UNITED STATES PATENT AND TRADEMARK OFFICE

APPLICATION NO.	FILING DATE	FIRST NAMED INVENTOR	ATTORNEY DOCKET NO.	CONFIRMATION NO.
10/702,104	11/04/2003	Gregory B. Altshuler	105090-0129	6794

Office Action Summary

DETAILED ACTION

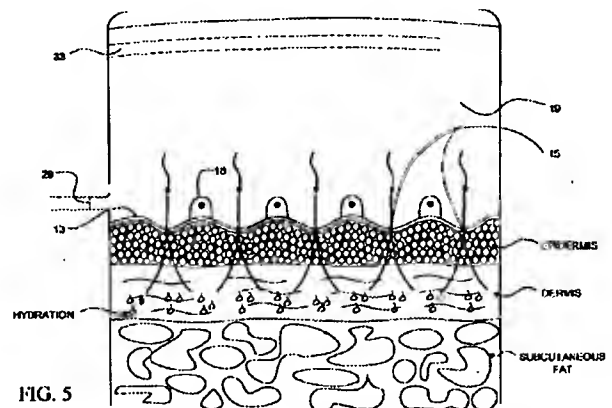
Claims 1, 22 and 23 are rejected under 35 U.S.C. 102(e) as being anticipated by U.S. Patent 6,350,276 to Knowlton. Knowlton discloses an apparatus for treating tissue using energy sources that may be light (Col. 7, lines 55-56). Figure 5 (herein), from a cross-referenced

(and
incorporated)
Knowlton
patent

(6,425,912), teaches energy sources (Fig. 5, # 18) that conform to the skin, the irregular surface forming

protuberances. Knowlton teaches cooling of the sources and tissue using a liquid (Fig. 2B, # 15) that can be in a liquid or gaseous state, or may exist in two or more phases and may undergo a phase change as part of its cooling function (Col. 5, lines 29-35), such as melting or evaporation (whereby heat is absorbed by the fluid as a latent heat of fusion or evaporation).
